| SUNDRY NOTICES AND REPORTS ON WELLS (DO NOT USE THIS FORM FOR PROPOSALS TO DRILL OR TO DEEPEN OR PLUG BACK TO A DIFFERENT RESERVOIR. USE "APPLICATION FOR PERMIT" (FORM C-101) FOR SUCH PROPOSALS.) | | WELL API NO. 30-015-21777 |

XTO Energy, Inc would like to PxA this well with the following procedure:

CONDITIONS OF APPROVAL FOR PLUGGING & ABANDONMENT

Well Name & Number: Nash Unit SWD #4

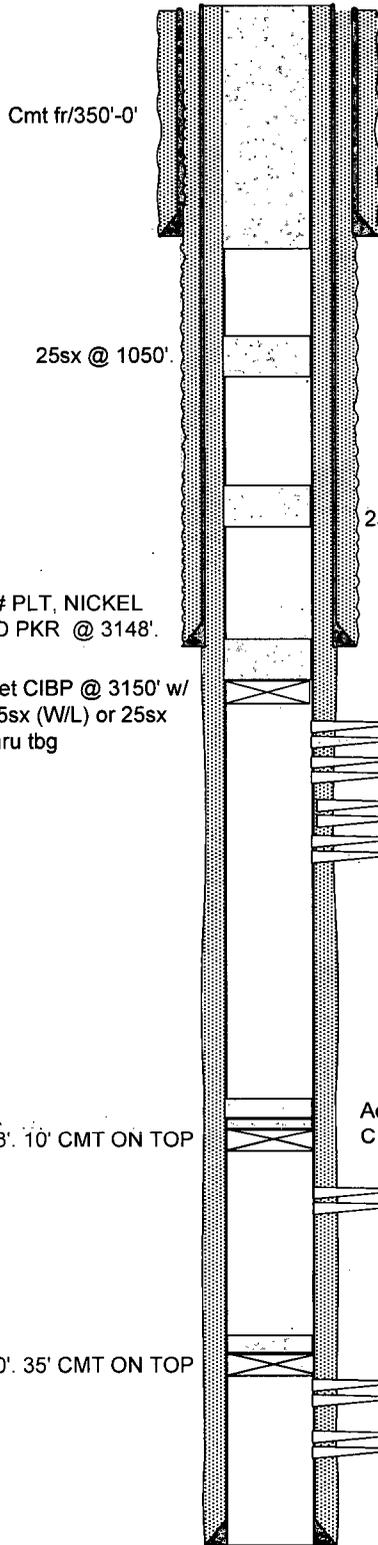
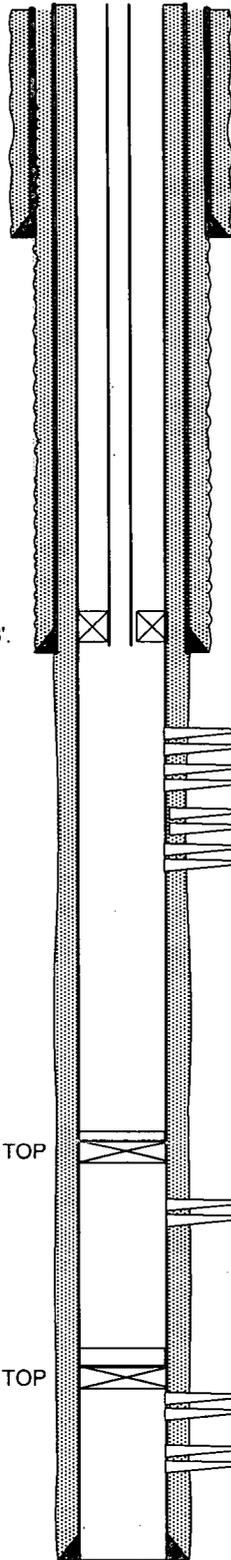
25sx @ 2150'.

Set CIBP @ 3150' w/ 35sx (W/L) or 25sx thru tbg

Add 15sx on existing CIBP & Cmt
